UNITED STATES PATENT AND TRADEMARK OFFICE

APPLICATION NO.	FILING DATE	FIRST NAMED INVENTOR	ATTORNEY DOCKET NO.	CONFIRMATION NO.
09/800,006	03/06/2001	James C. Rush	STE01 P-1086	5256

Office Action Summary

DETAILED ACTION

3,513,606

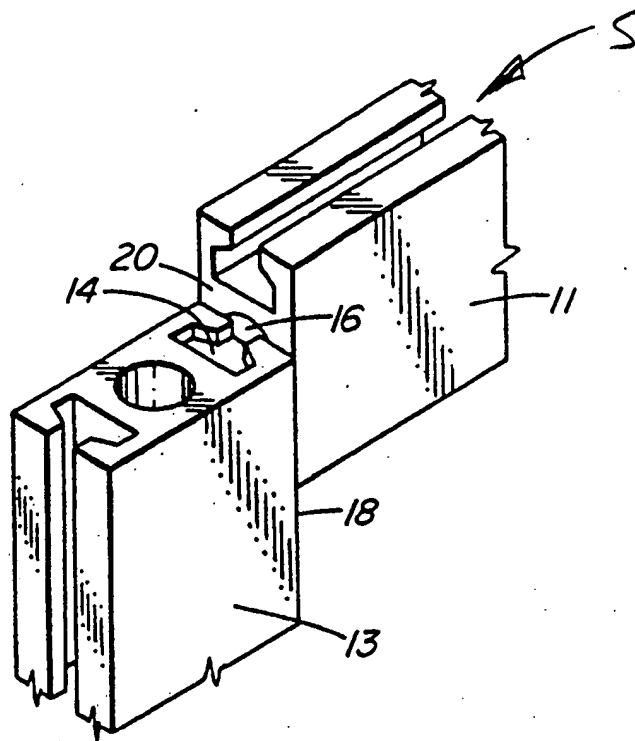
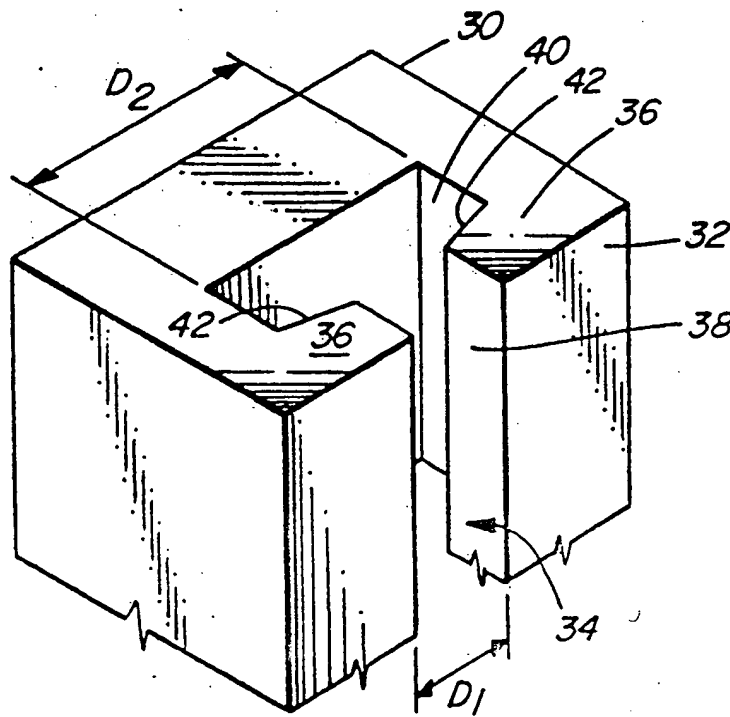
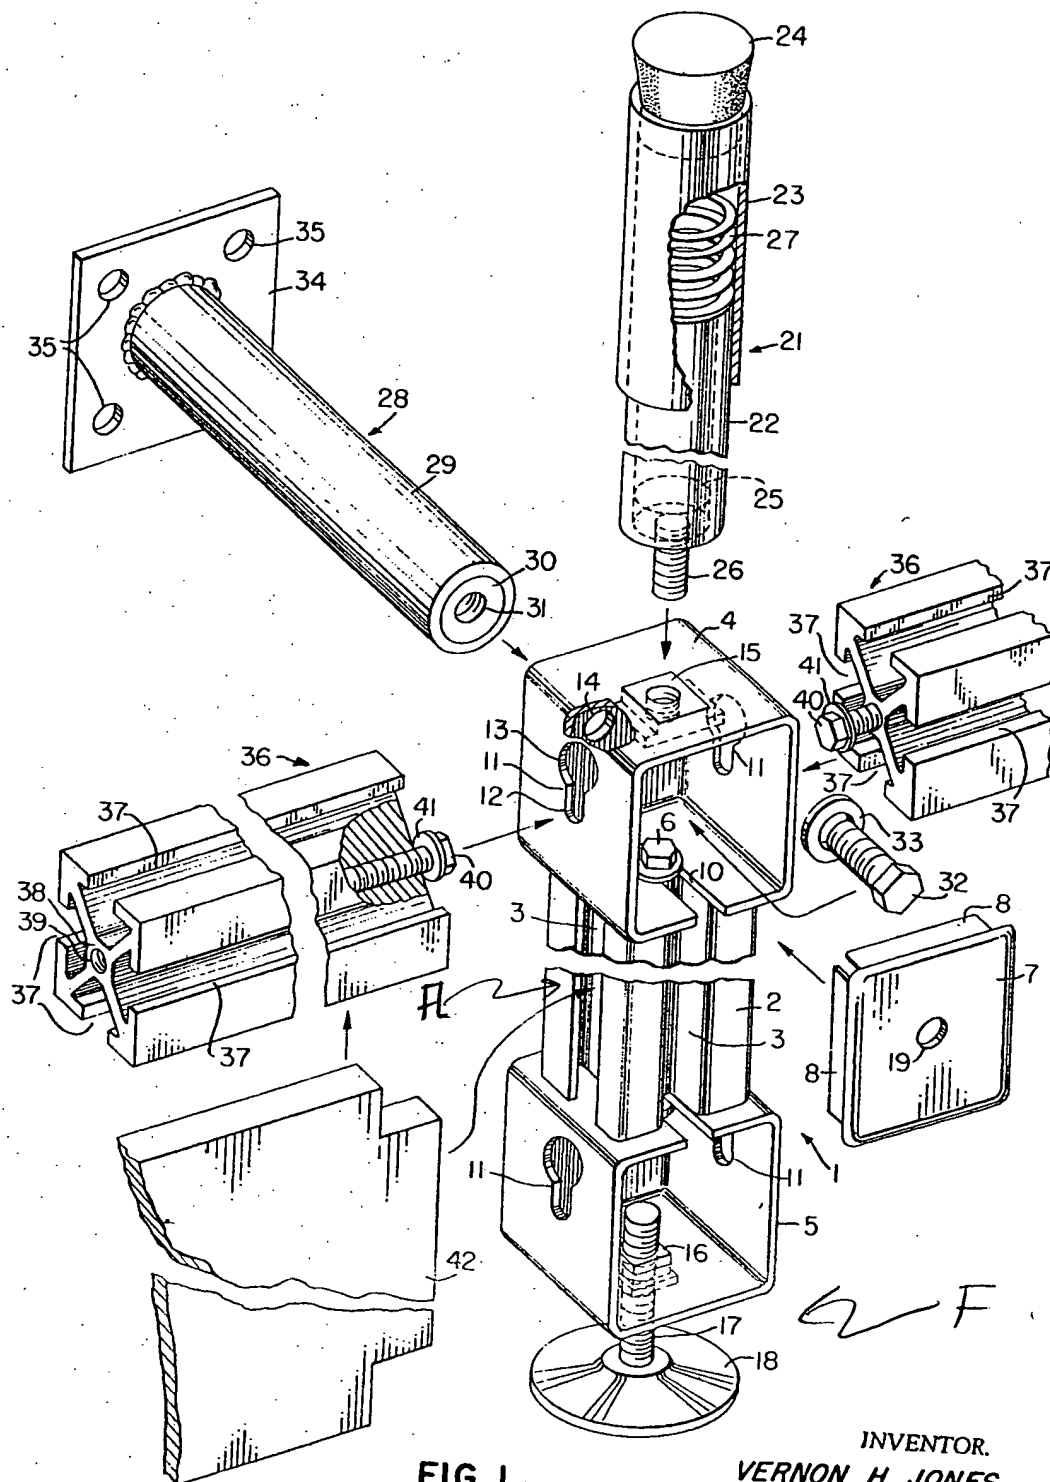
3. Claims 1 and 27 stand rejected under 35 U.S.C. 102(b) as being anticipated by US Patent #3,513,606 to JONES. JONES discloses a furniture system including a plurality of overhead

beams (36) having an upper surface including a single horizontal slot (37), a plurality of vertical posts (2) having outwardly extending flanges (FL) and an end face with a vertical central slot (3), and a plurality of connectors (4,40). The slots (3) are generally T-shaped with an enlarged interior track portion (IT) and a reduced neck portion (N) and the connectors (4,40) are shaped to be received within the slots (3). The overhead beams (36) have slots (37) in a lowermost face thereof, see attachment. Regarding claim 27, the vertical posts (20) include hollow bases (5) with adjustable leveling telescoping feet (F), see attachment.
